PROJECT : HONOAPIILANI HIGHWAY
Kahana to Alaeloa

PROJECT NO.: F-030-1(13)

DRAINAGE

STATE OF HAWAII
DEPARTMENT OF TRANSPORTATION
LAND TRANSPORTATION FACILITIES DIVISION
DRAINAGE & IRRIGATION PLAN
HONOAPIILANI HIGHWAY
Kahana to Aiealoa
F.A. Proj. No. F-030-1(13)

Scale: 3/4" = 1'-0"

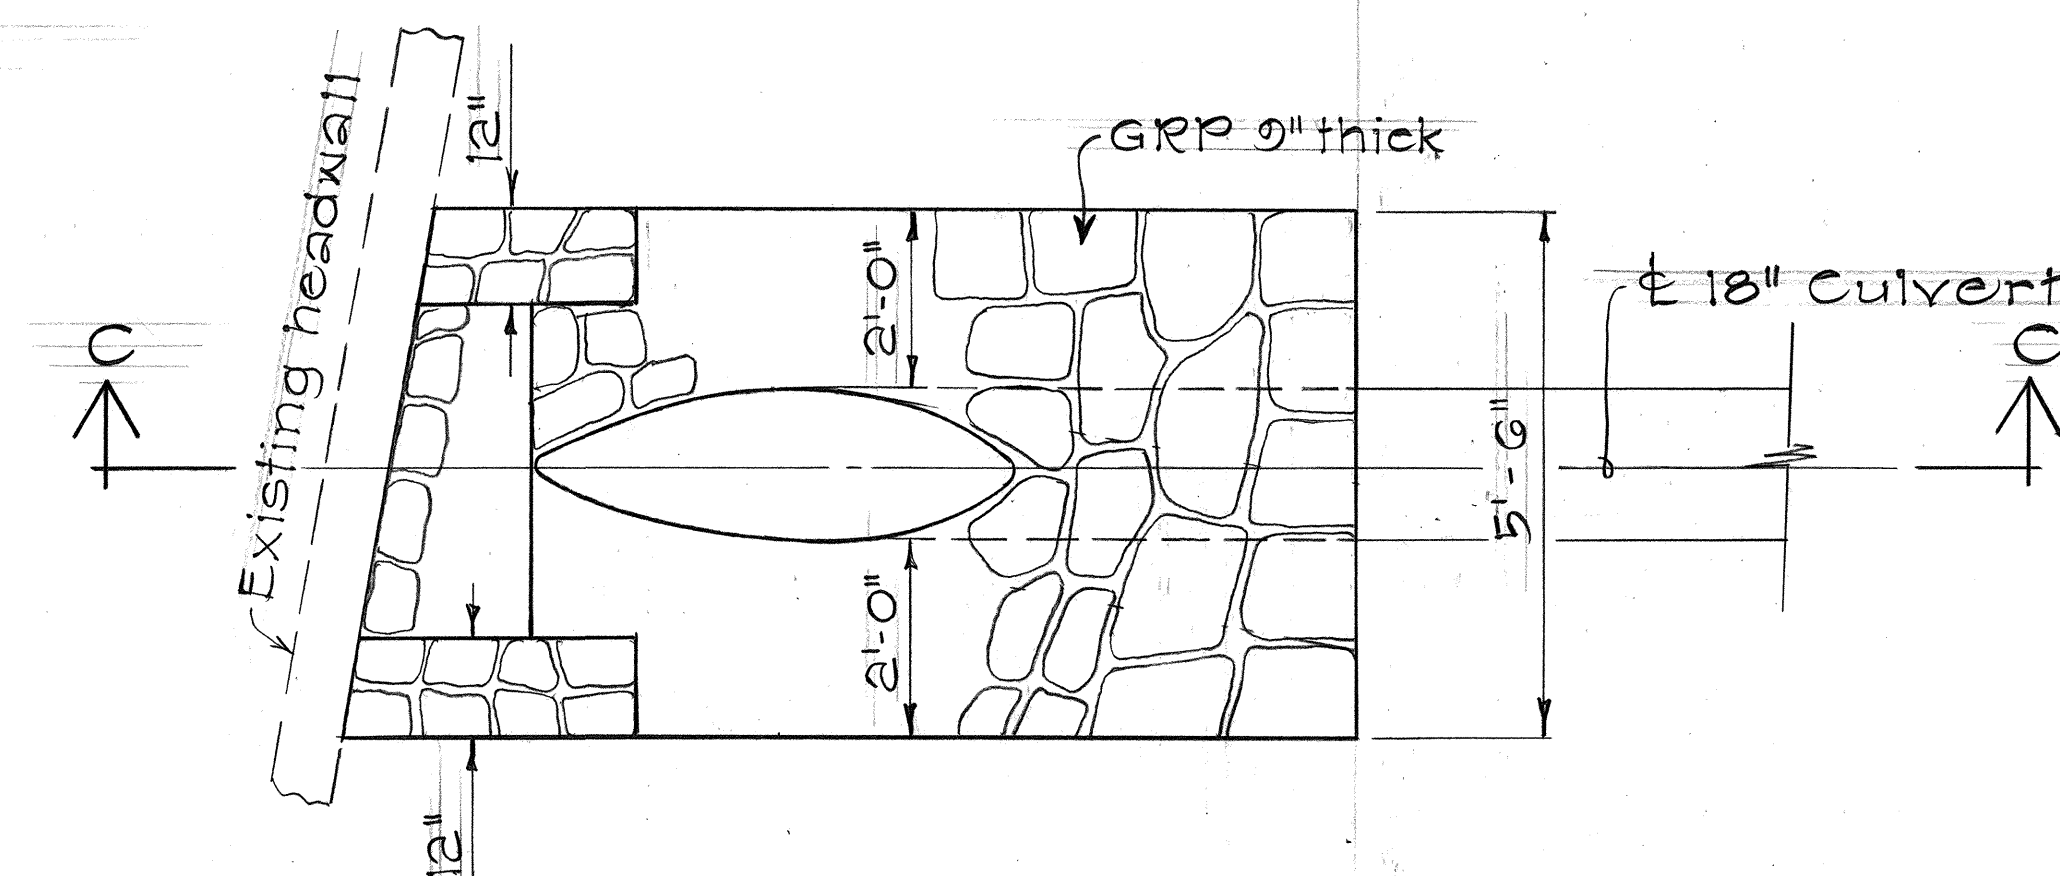
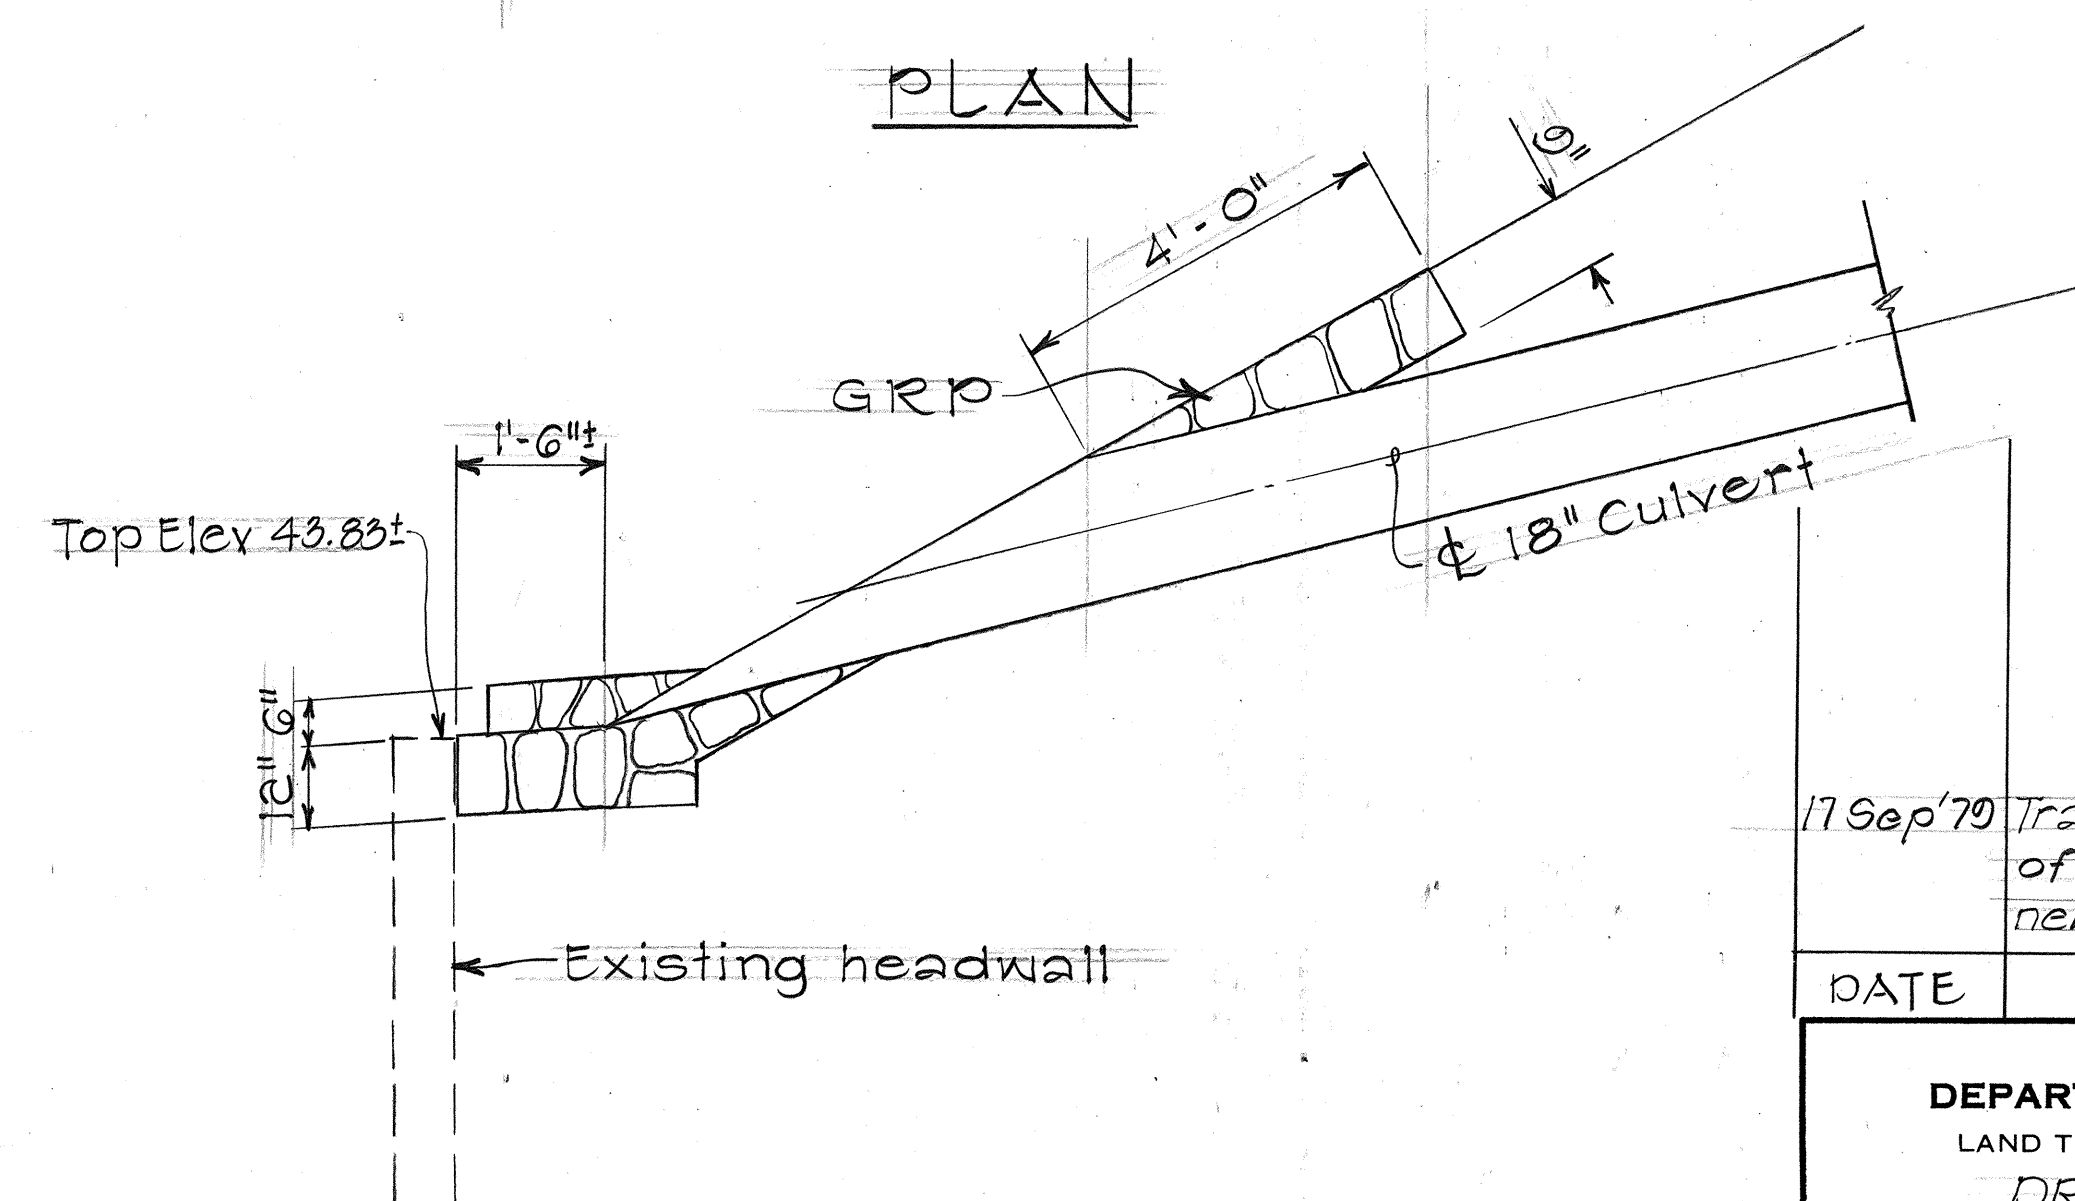
17 Sep 79 Tracing added to show details of drainage structures for new roadway intersection.

SHEET NO. 12 OF 31 SHEETS

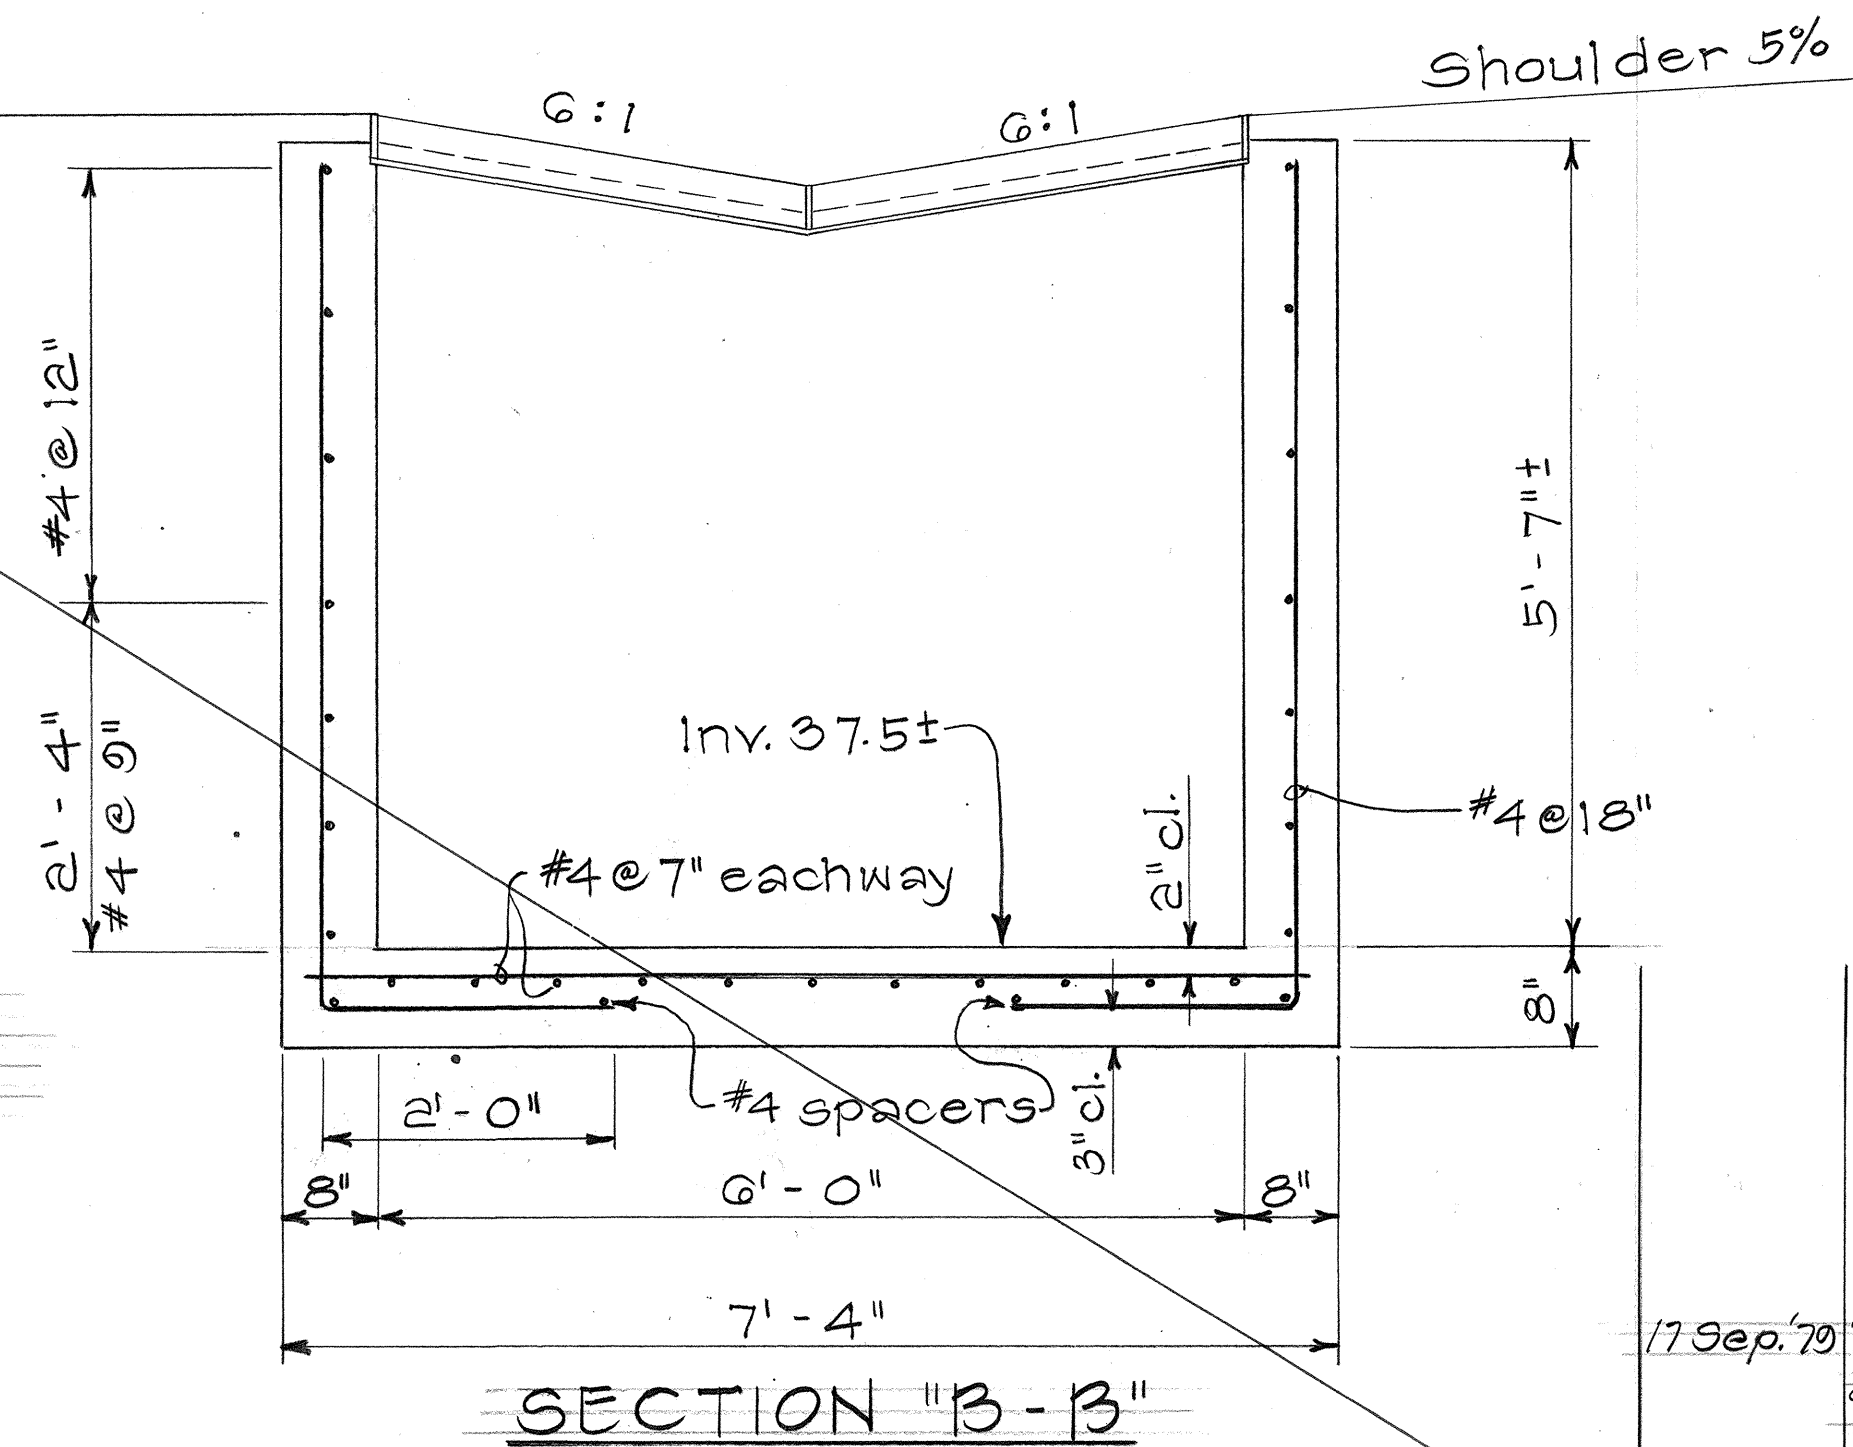
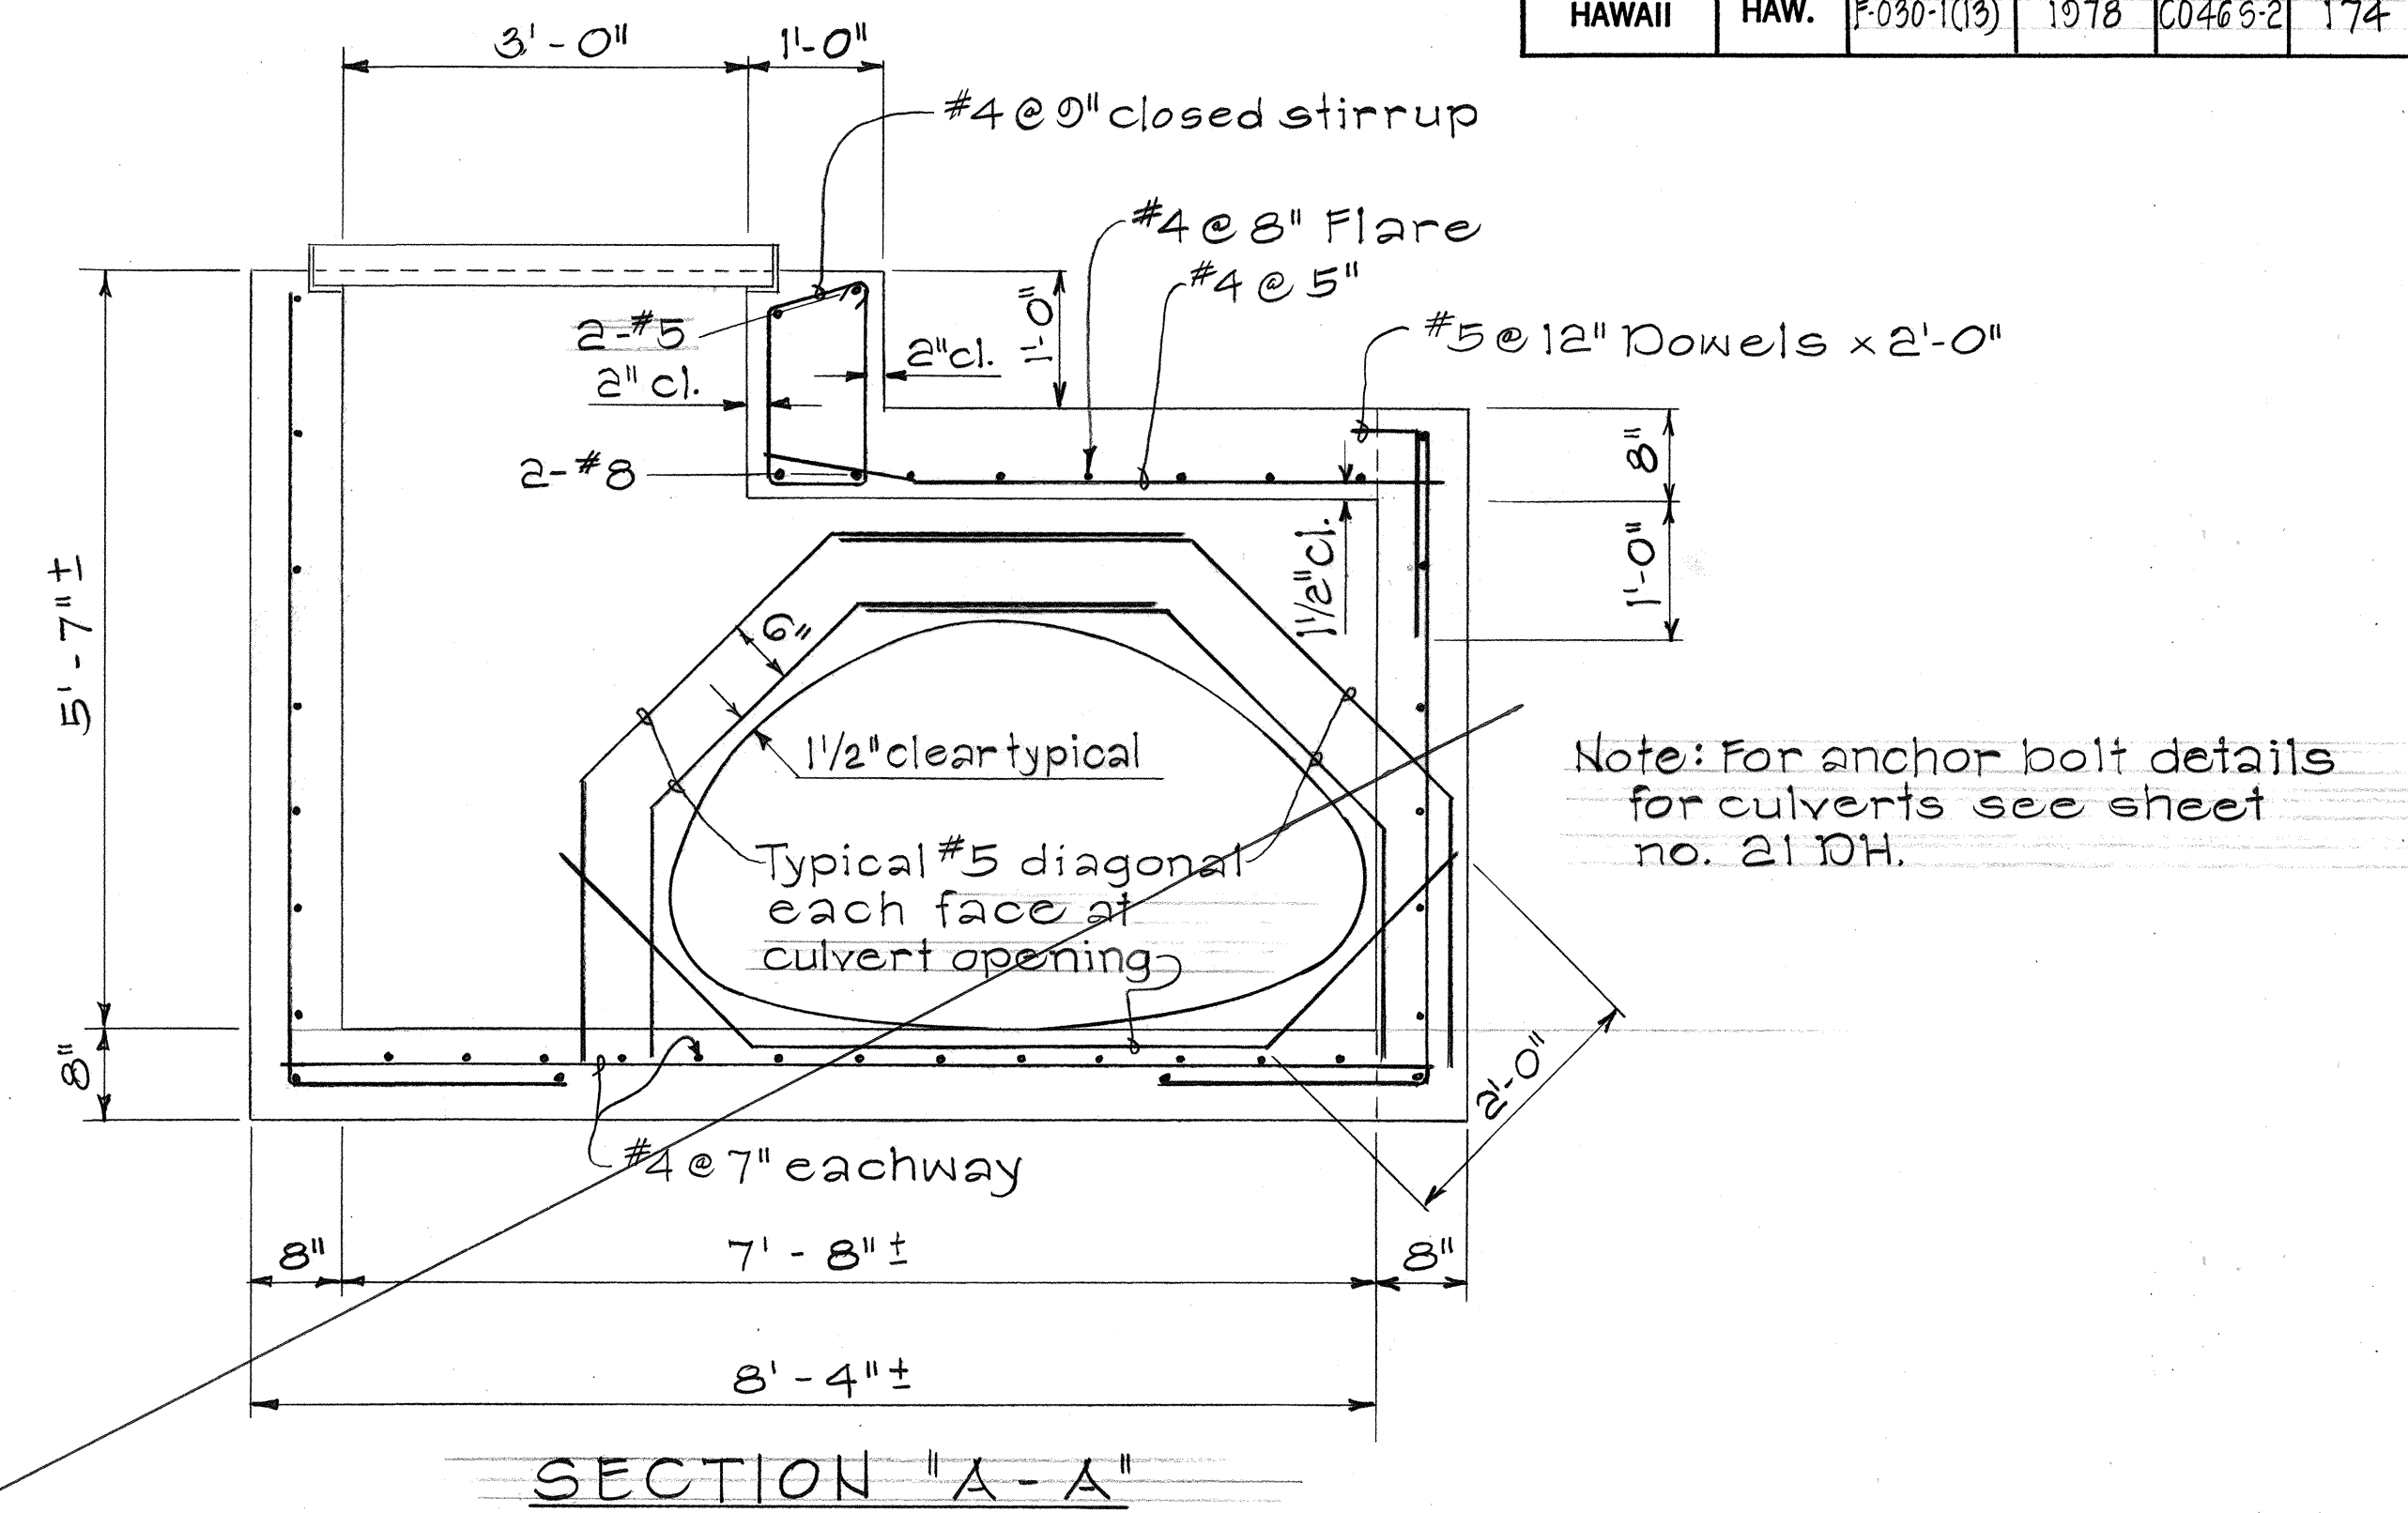
17 Sep '79 Tracing added to show details of drainage structures for new roadway intersection.
